SUBMITTAL FOR APPROVAL

Exxel Pacific, Inc.
201602. - The Cora Apartments (19 W Harrison)

We are transmitting the following **Submittal Package 22 0000-05 - Tub & Shower Data**; Rev 0 item(s) for your review in accordance with the contract specification # 22 0000.

Re: Cora Apartments – Tub & Shower Submittals

TS1 - BATHTUB-SHOWER COMBO - TYPE B

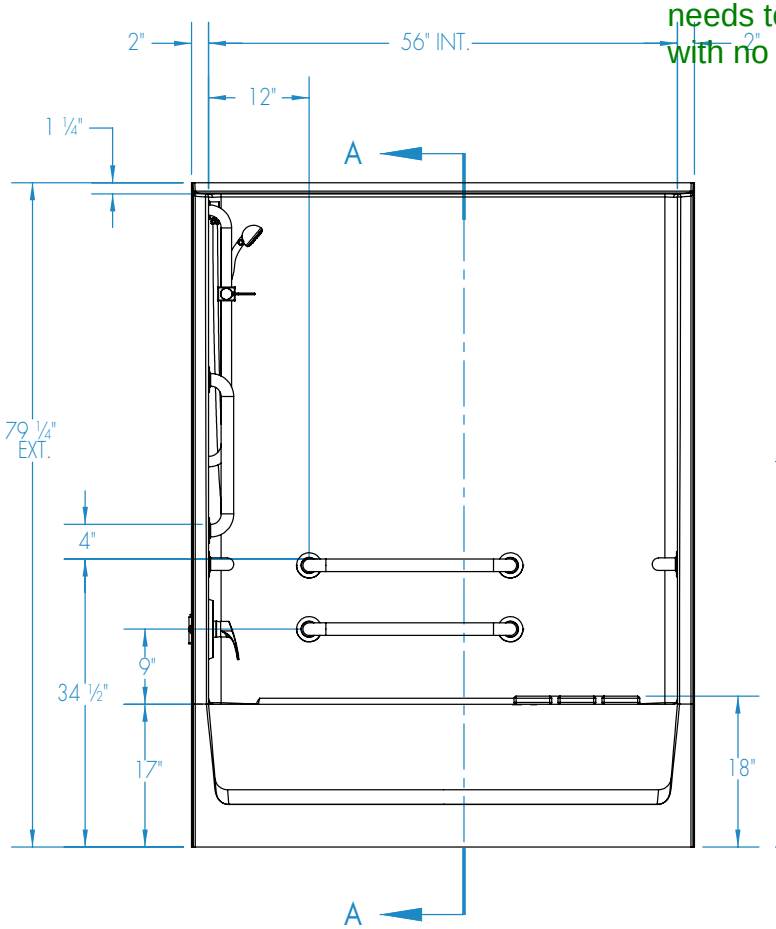
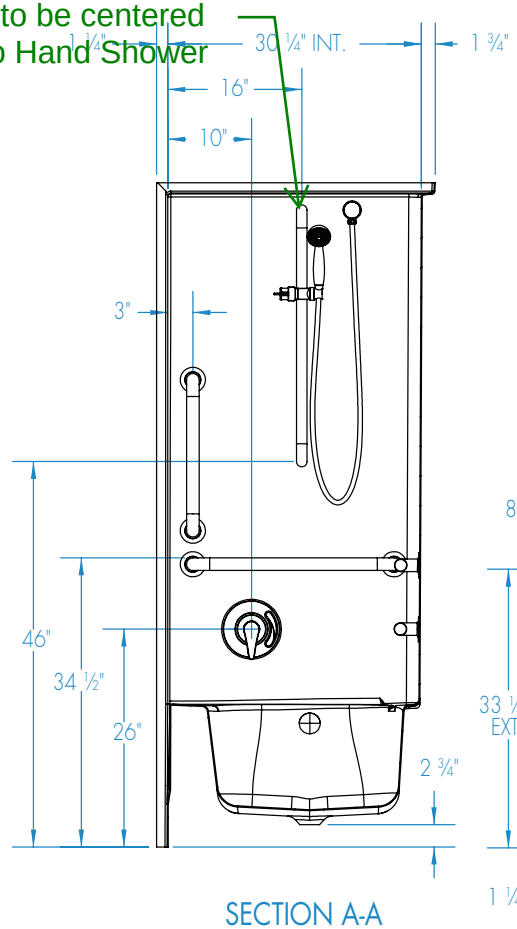
shower head location needs to be centered with no Hand Shower

Grab bars, seat, hand shower will not be provided on this unit. See memo attached for control elevations and showerhead rough-in locations.

TS2 - BATHTUB-SHOWER COMBO - TYPE A

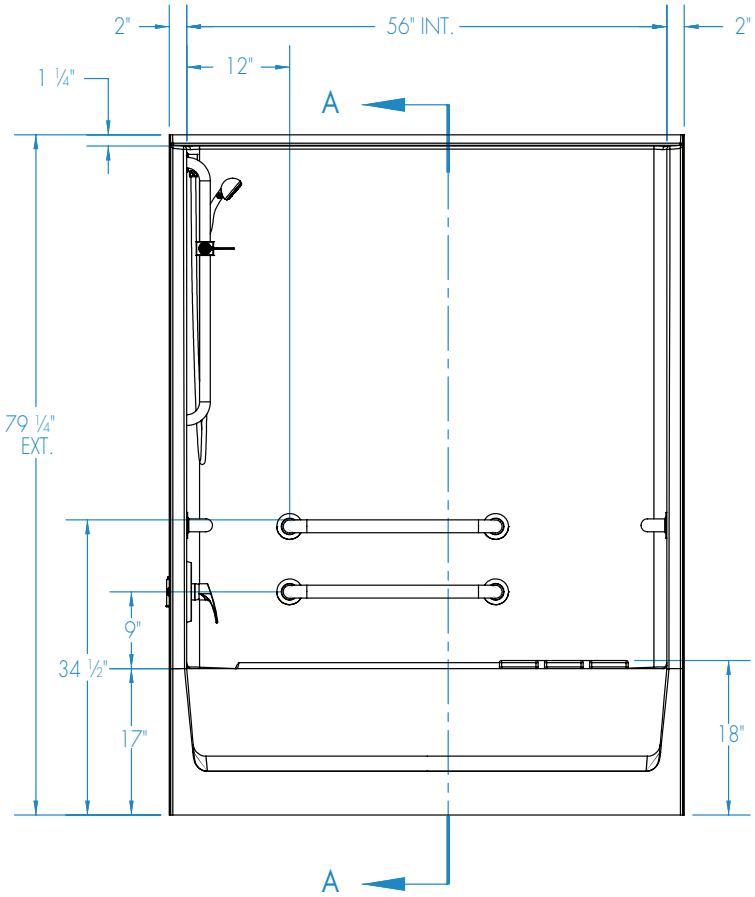
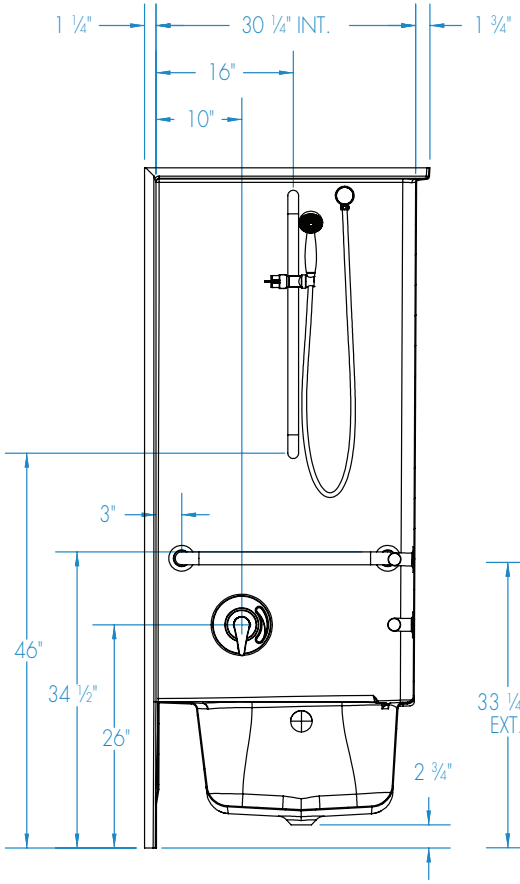
Hand shower will be provided in separate submittal. See memo attached for control elevations and showerhead rough-in locations.
